Bulletin | Danfoss Turbocor Compressors

Customer Notification

B-CN-054-EN REV B

SUBJECT: VTT Update - Major Revision 'C' Change Implementation

Compressor Interface Module (CIM)

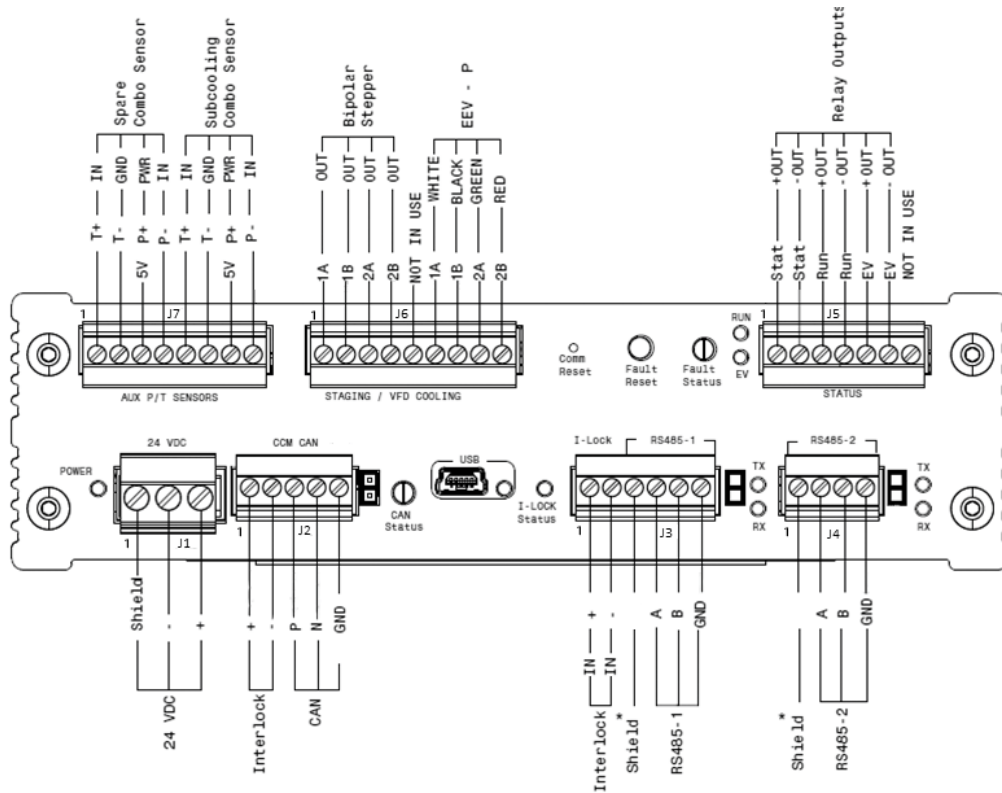
While, at the time of this bulletin, there are three different CIM revisions, they all have the same outward appearance. One exception to this is Revisions A and B do not contain pin or connector numbers. An illustration of a CIM (Revision C) is shown below. Please refer to this illustration when connecting cables to the CIM.
